NRC Inspection Report (IR) Nos. 50-315/97-24, 50-315/99-10

Event Description: Lack of a procedure for manually backwashing the emergency service water pump discharge strainers

Plant: Donald C. Cook Nuclear Plant, Units 1 and 2

**Figure 2.** Seismic-induced station blackout event tree.

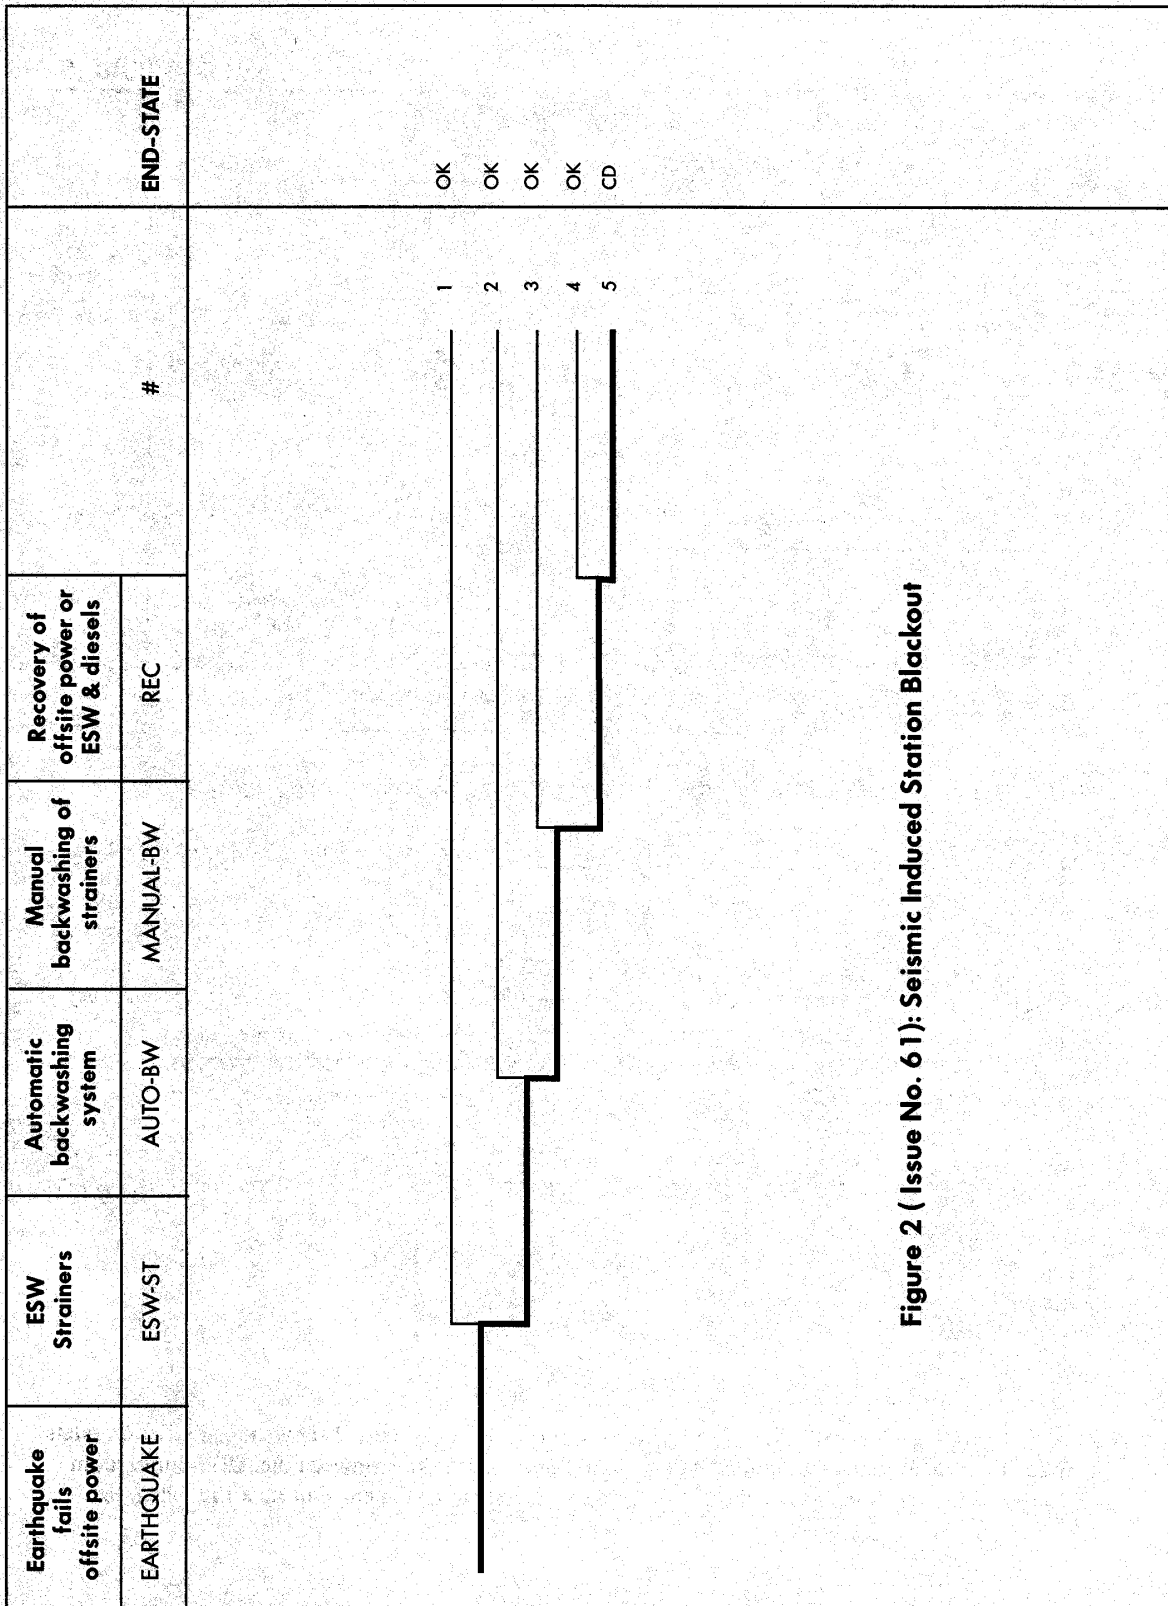
1. **Comment from Licensee:** The following comments apply to Sequence 2, "Loss of Offsite Power and Emergency Service Water due to Earthquake and Auxiliary Feedwater failure."

In the postulated event, an earthquake occurs causing failure of offsite power and automatic emergency service water backwashing capability. The automatic backwashing function is demanded due to the earthquake stirring up sand and debris in the lake. Manual backwashing fails, leading to emergency diesel generator unavailability and core damage occurs due to the station blackout.

Although there was no procedure to manually backwash the strainers, inspection and maintenance (I&M) has concluded that it would be unlikely that the emergency service water system would fail due to plugging of the strainer caused by a seismic event. The basis for this conclusion is provided below.

It was assumed that the energy added by a seismic event would generate waves and turbulence in the lake similar to those induced during stormy weather conditions and this would result in a challenge to the automatic backwash capability of both emergency service water trains. However, the emergency service water system at Cook has never functionally failed despite the occasional very severe weather conditions that occur on Lake Michigan.

3. **Comment from Licensee:** Even if the sand did plug one strainer, the clogged duplex strainer would have to fail to shift, or after the strainer shifts, the clean strainer basket would have to plug or otherwise fail.

4. **Comment from Licensee:** In addition, the standby emergency service water pump and its associated strainer baskets would have to fail.

5. **Comment from Licensee:** Even if all four operating strainer baskets were to plug and automatic backwashing were to fail, or if the strainers failed to shift, the operators and maintenance staff have more than two hours (based on the current Cook IPE) to restore at least one strainer and place an emergency service water pump in service.

6. **Comment from Licensee:** Restoration of emergency service water would allow operation of at least one emergency diesel generator and provide ventilation cooling to any of the auxiliary feedwater pump rooms. Even without room cooling, the turbine driven auxiliary feedwater pump can operate 4 hours once the door to the room is open (per the station blackout analysis). In summary, I&M's position is that a design basis earthquake would not be expected to cause a loss of the emergency service water system due to plugging of the strainers. Therefore, consideration should be given to reducing the failure estimate for this event.

Based on the preceding discussion, I&M believes that the analysis in Sequence 2 should include the frequency of failures of both the standby emergency service water pump and the turbine driven auxiliary feedwater pump. If each of these events is conservatively estimated to have a failure probability of 0.1 ($1.00 \cdot 10^{-1}$), then a core damage frequency of 3.06×10^{-7} would be obtained. This value is below the ASP threshold.

Response: The licensee has commented that since the emergency service water system at Cook has never functionally failed in spite of stormy weather conditions which it has experienced in the past, it is unlikely that the emergency service water system would fail due to plugging of the strainer caused by the seismic event.

We considered the basis of the licensee's comment and concluded that emergency service water could fail during an earthquake (even though it has not failed during storms) since an earthquake would not only plug up the strainer (similar to a severe weather condition) but also fail the automatic backwashing capability. The manual backwash capability did not exist at Cook due to lack of procedures and tools.

However, during an earthquake, in addition to the plugging the strainer basket, the automatic shift capability will also fail due to inadequate seismic capacity of that system. In addition, there were no procedures or equipment readiness to recover from this condition. Consequently, the running emergency service water train would fail after an earthquake.

Response: As pointed out on Page 8 of Appendix A, the automatic backwash capability was not seismically qualified. Furthermore, it was degraded. According to Section M2.1 of the inspection report No. 50-315/99-010(DRP), the air lines to the backwash valves were improperly supported. Even when air lines are properly mounted, Individual Plant Examination External Events (IPEEE) and USI A-46 studies assumed that these lines would be unavailable after an earthquake. Since these air lines (which were not seismically qualified) were not properly supported, they could not be relied upon to function after an earthquake.

Response: During normal operation, only one of the two emergency service water pumps for each Cook unit is in operation (i.e., for both units, two pumps would be running). However, after the loss of normal power which is caused by the postulated earthquake, after load shedding, both emergency service water pumps (all four emergency service water pumps for the two units) will be started. As a result, one of the two strainer baskets in each emergency service water strainer would plug up.

Response: As stated in one of our previous responses to your comments, the degraded condition of the automatic backwash capability of Cook's emergency service water was compounded by the fact that in August 1997, Cook did not have procedures or training to implement manual backwashing. Consequently, in the event of the failure of the automatic backwash capability, staff could not rely on the manual backwash capability {Note: Both the Accident Sequence Precursor (ASP) analysis guidance as well as guidance developed for the Significance Determination Process of the new Reactor Oversight Process examines whether procedures and training exist before recovery actions are credited.}

Response: The staff did not credit the turbine-driven auxiliary feedwater since without room cooling this pump could fail after several hours. Furthermore, even if the turbine-driven auxiliary feedwater was available, extended station blackout would lead to core damage due to either reactor coolant pump seal failure or battery depletion. The standby emergency service water pump could not be credited since that pump also fails due to the earthquake.
